# JABIRU AIRCRAFT PTY LTD

**SERVICE BULLETIN: JSB 029-1**  
**Issue: 1**  
**Date: 20<sup>th</sup> January 2011**  
**Subject: J170 Handling Upgrade**

Figure 2 – New Rudder Centring Springs

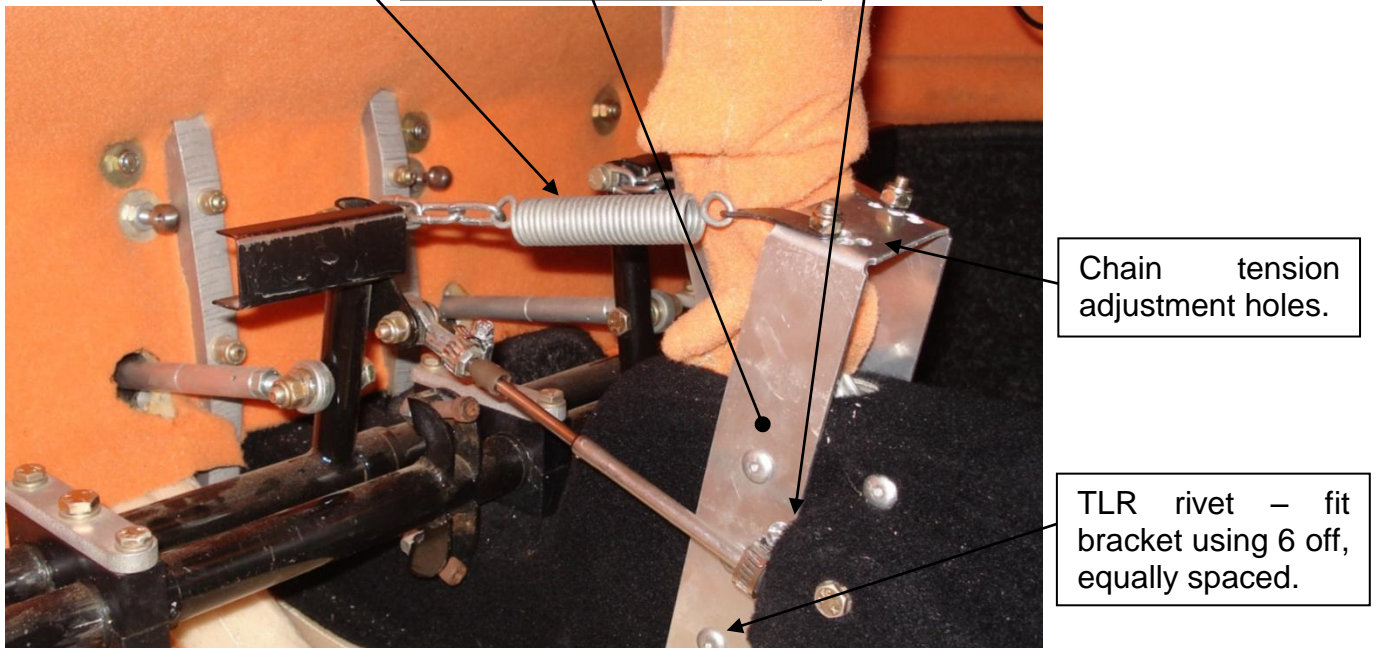
- Remove the existing rudder springs and chains from the rudder pedals.
- Fit the new spring mounting bracket to the aircraft's centre console using 6 off TLR rivets as shown in Figure 2. The exact position is not critical – but it should be aligned with the front of the rudder cable mount and positioned so that the chains and springs run as straight as possible.

- Fit the new springs as shown in Figure 2. Adjustment of these springs is important for correct handling of the aircraft. The springs must be set so that when the rudder pedals are centered neither spring is carrying any load – but as soon as the pedals move slightly a spring takes up tension. If the springs are set too tight – i.e. when the pedals are centered both springs are carrying some tension – this will reduce the centring effect of the spring system and must be avoided. If the springs are set too loose the pedals must move too far before there is any centring effect – this makes the system ineffective near centre and must also be avoided.

New rudder centring spring & chain assembly

Spring anchoring bracket – rivet to centre console

Align rear of bracket to front of rudder cable mount

Figure 3 – Fitting Adaptor to Drive Arm

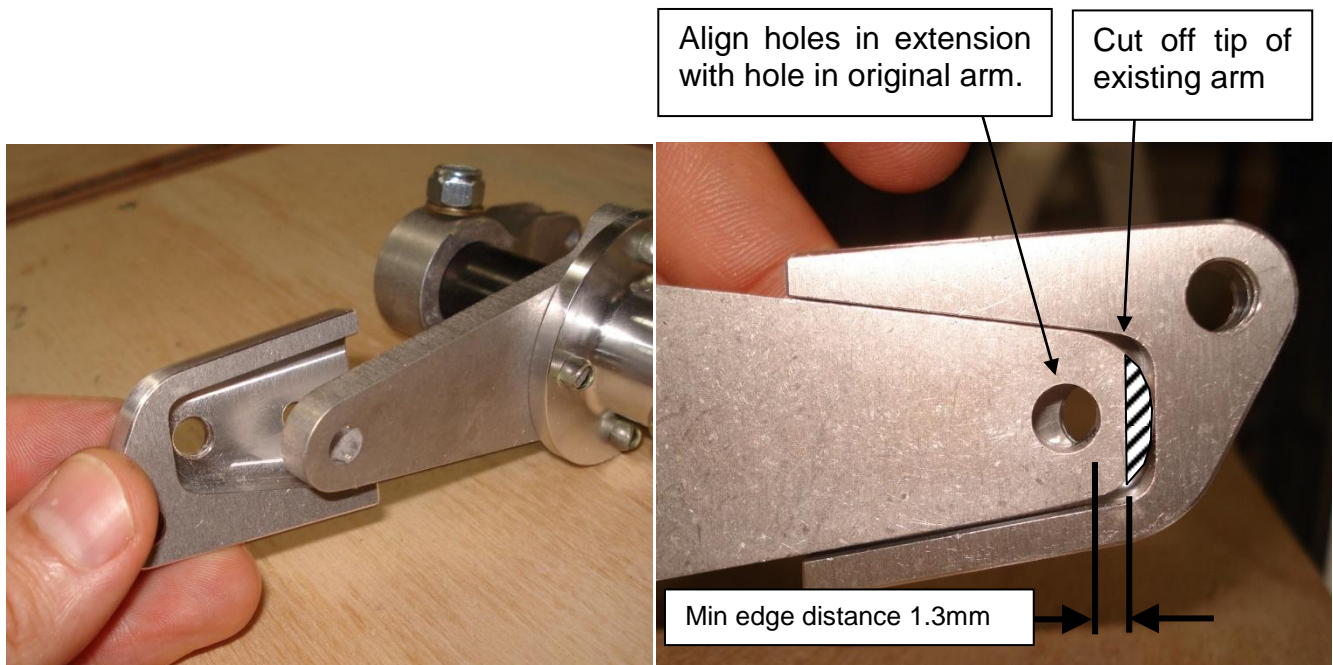
- Apply the new drive adaptor to the existing internal flap drive arm from the outboard side – it will be obvious how much material must be removed from the existing arm to fit the adaptor. Figure 3 (right) shows this. Carefully remove this material, removing just enough so that the extension slides onto the arm far enough to align the bolt holes and to fit snugly around the arm. De-burr the tip. Note the minimum edge distance shown in Figure 3 (right).

Figure 4 – Adaptor in Place

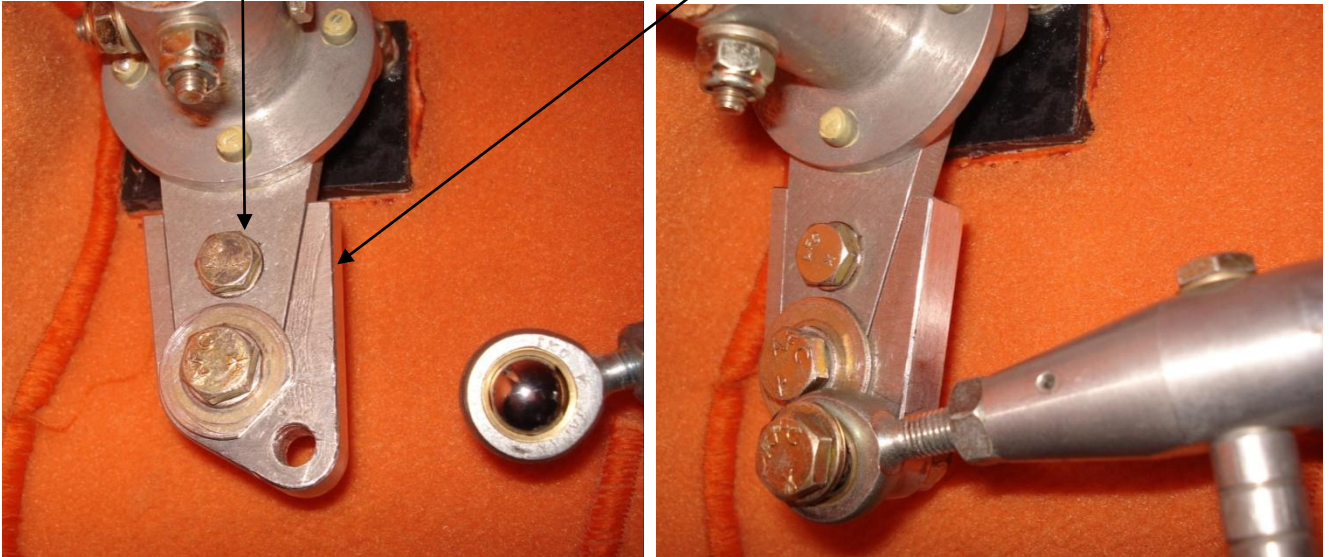
- Remove the adaptor from the drive arm. Clean it using Acetone. Mix and apply 5-minute epoxy resin to its socket.
- Bolt the adaptor to the arm using 1 off ¼” and 1 off 3/16” bolts, orienting it as shown in Figure 4. Wipe off any excess resin. Both bolts can be fitted from the cabin side of the drive arm – care will be needed to use the correct length bolt so that the tails of the bolts do

Use the 3/16" hole in the adaptor as a guide to drill a matching hole in the existing arm

Adaptor bolted & bonded in place. Use of penny washer is optional.

Figure 5 – Flap Drive Modification

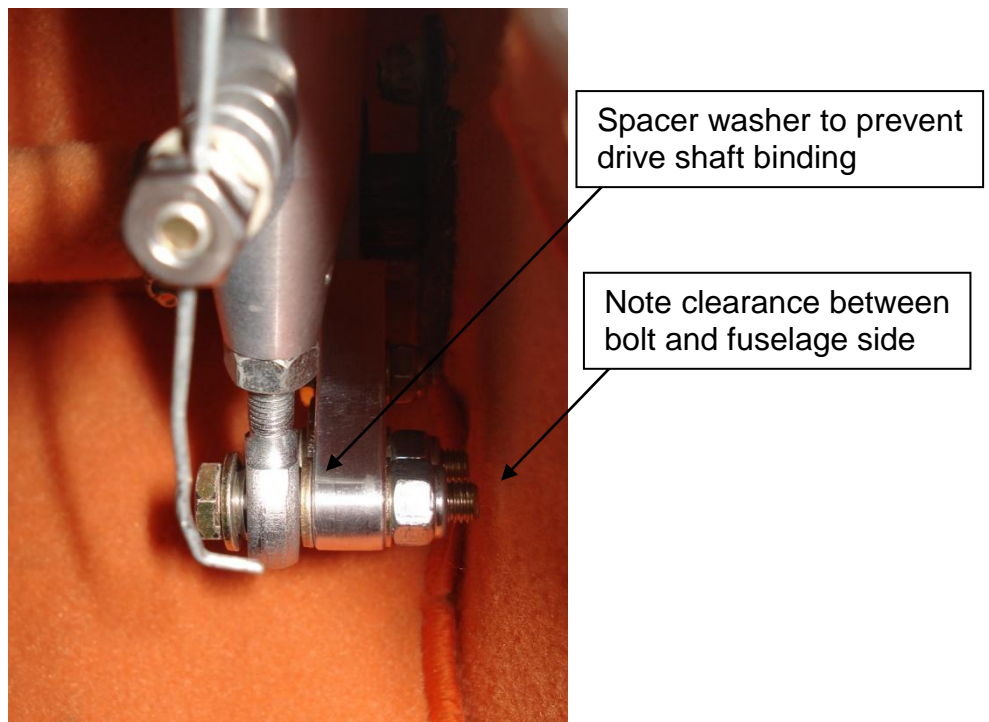
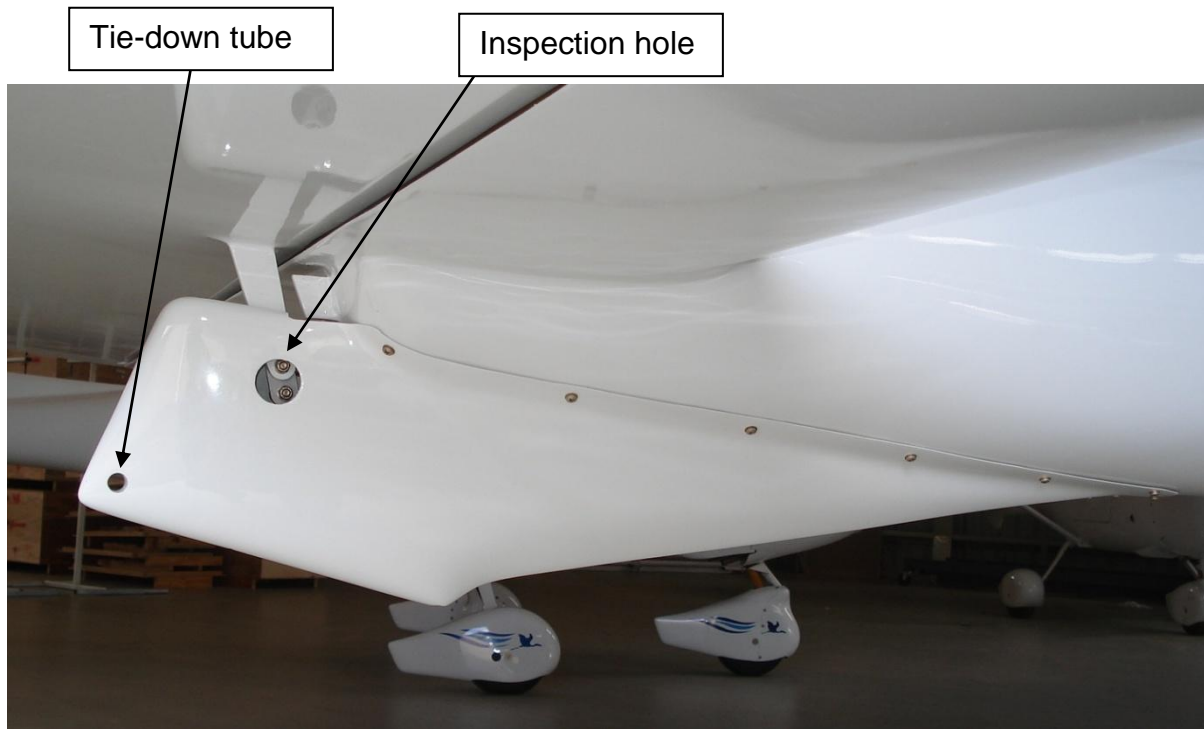
- Turn the aircraft master power on and drive the motor to the fully “down” position, then turn the master power off.
- Once in position, adjust the rod end in the motor shaft to align with the lowest hole in the adaptor and re-connect it using a ¼” bolt. Note that if there is not enough adjustment in the rod end the external flap drive pushrods can be adjusted to suit. Again, AN363 or MS21042 nuts may be used if required to give clearance from the fuselage.

- Remove the tape or stands from the flaps.
- Turn the aircraft master power on and cycle the flaps, checking for smooth operation with no binding or other issues. Measure the flap deflection – between full up and full down positions the flaps must travel  $30^{\circ} \pm 1.5^{\circ}$ .
